Location
Victoria Embankment Foreshore
City of Westminster

Document Information
Application for Development Consent
Site works parameter plan

Book of plans - section 18
DCO-PP-16X-VCTEF-180008 - Rev 4
May 2020

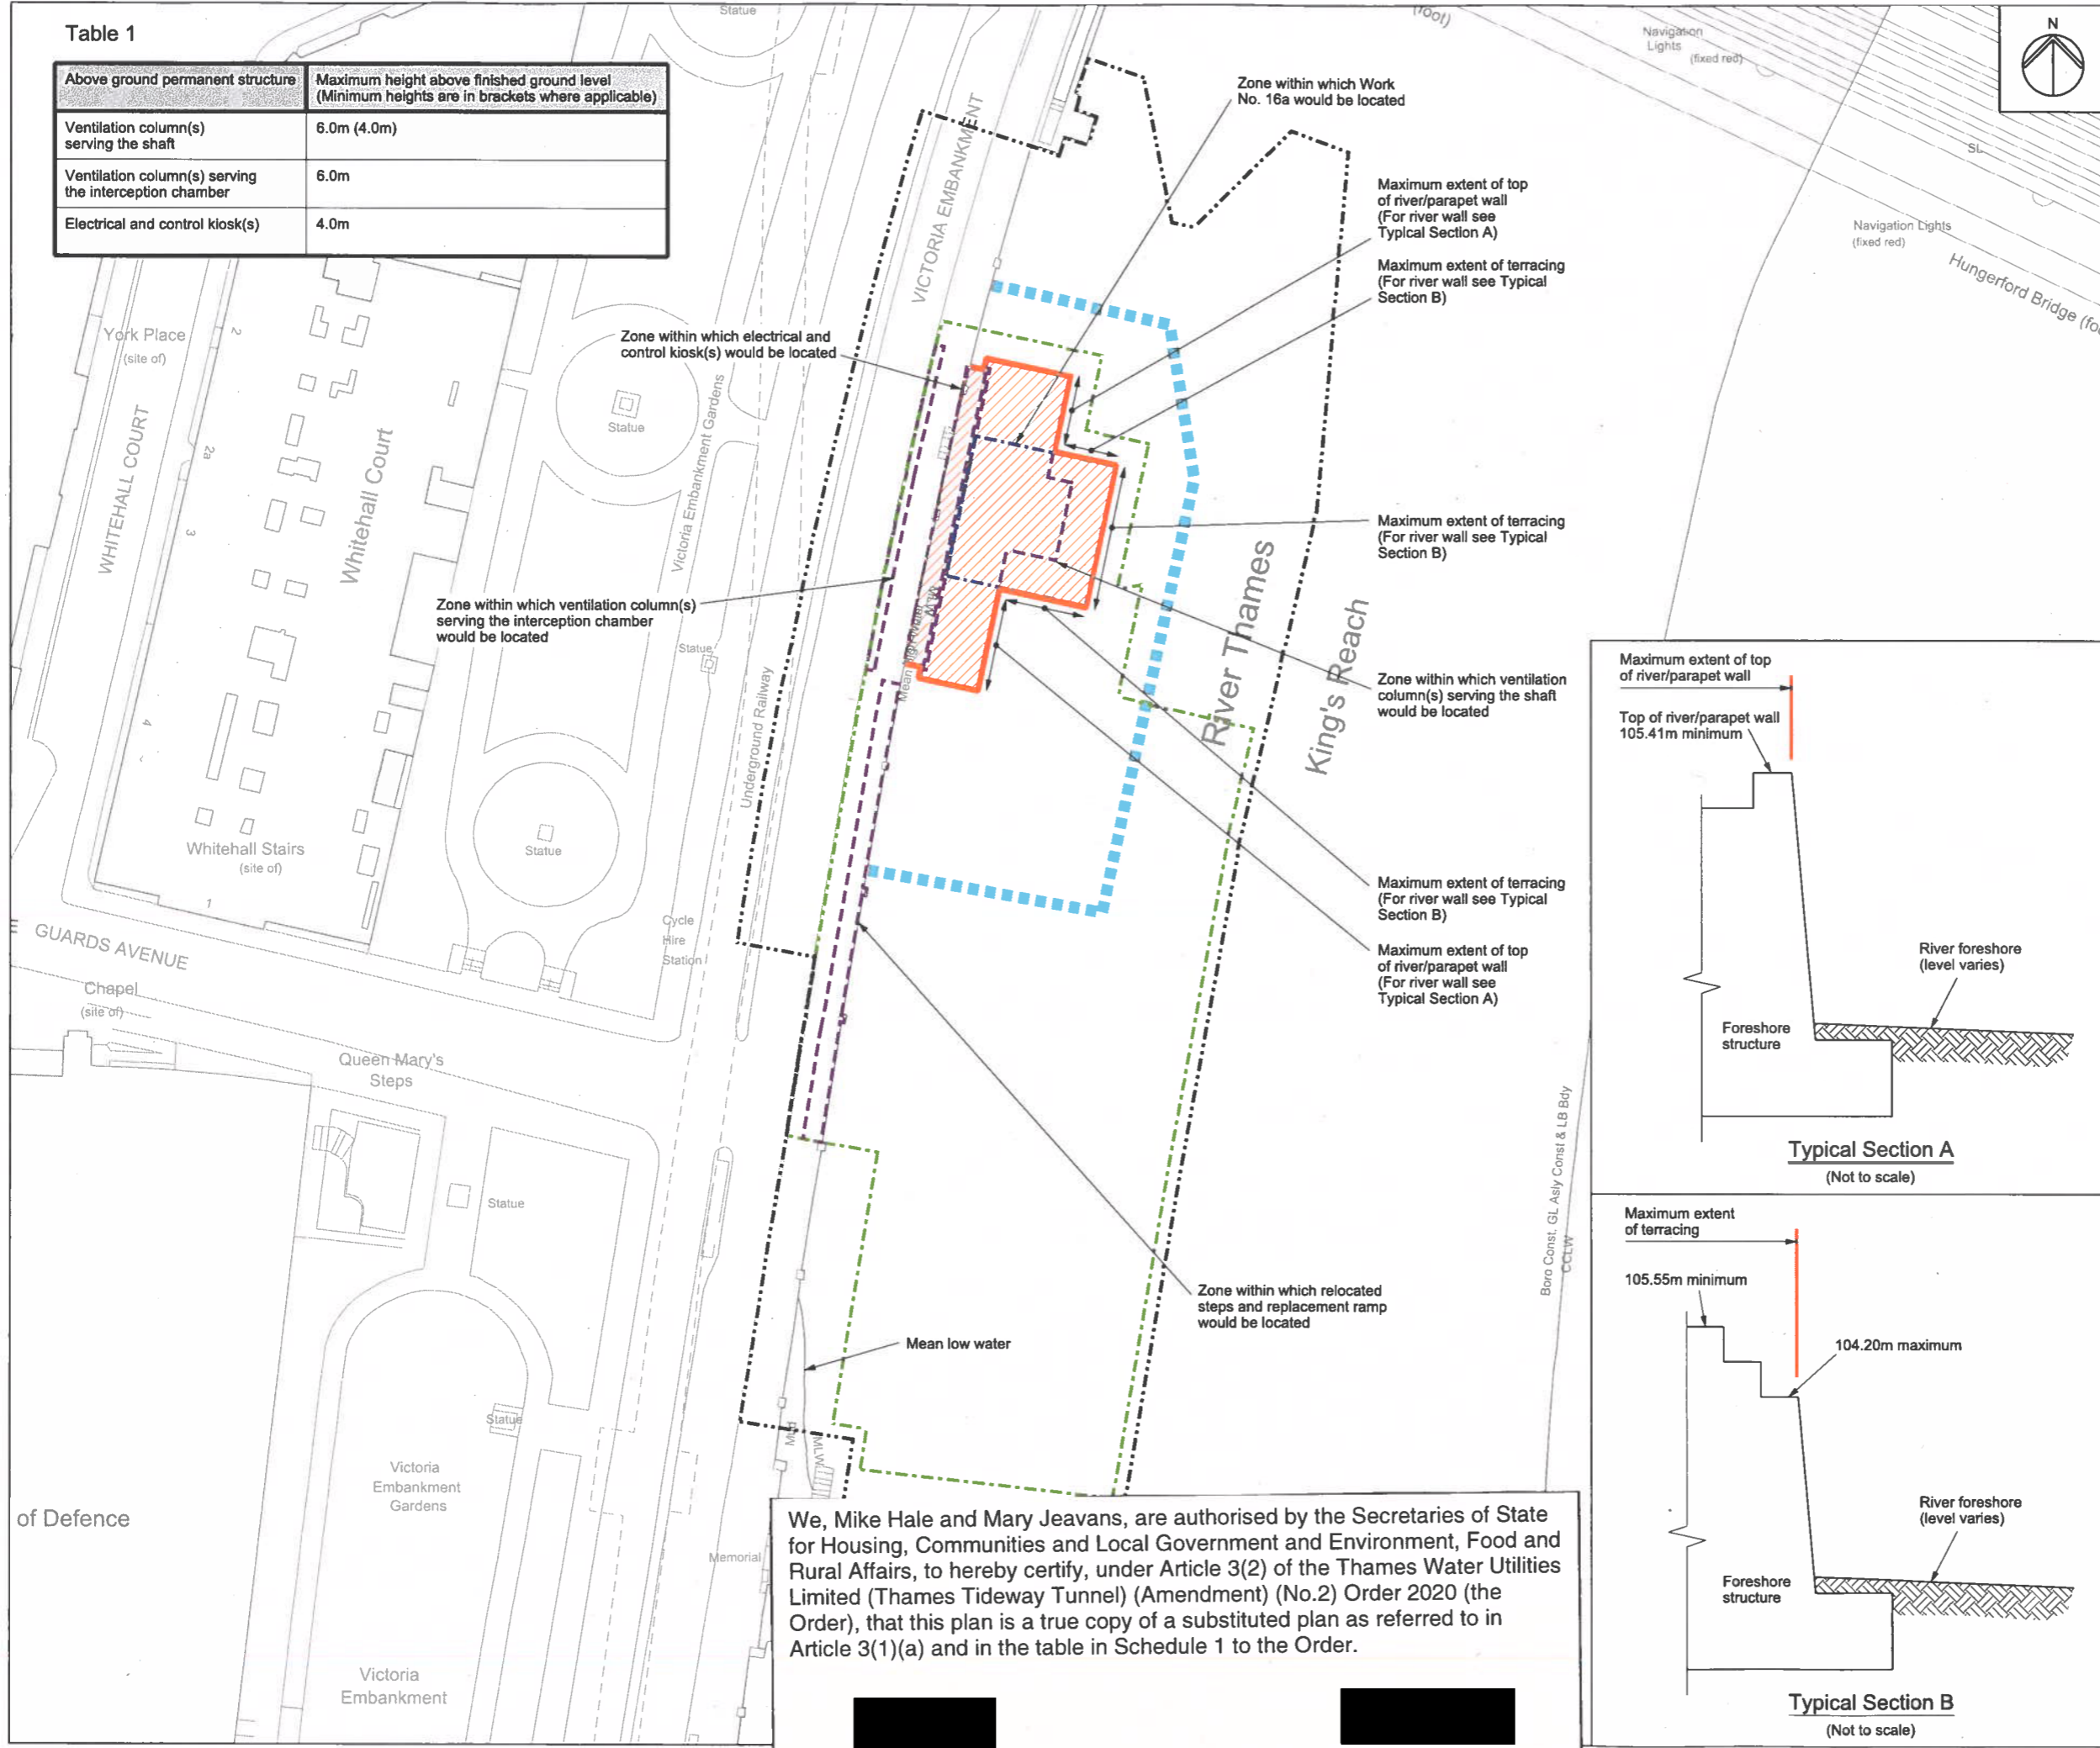
- Rev 1:**
- LLAU, zone within which all permanent site structures would be located and zone within which permanent above structures would be located extended.

- Rev 2:**
- Maximum height of electrical and control kiosk(s) reduced in table 1.
 - Zone within which all permanent site structures would be located reduced.

- Rev 3:**
- Maximum height of ventilation column(s) serving the shaft reduced in table 1.

- Rev 4:**
- Zone within which the shaft would be located increased.
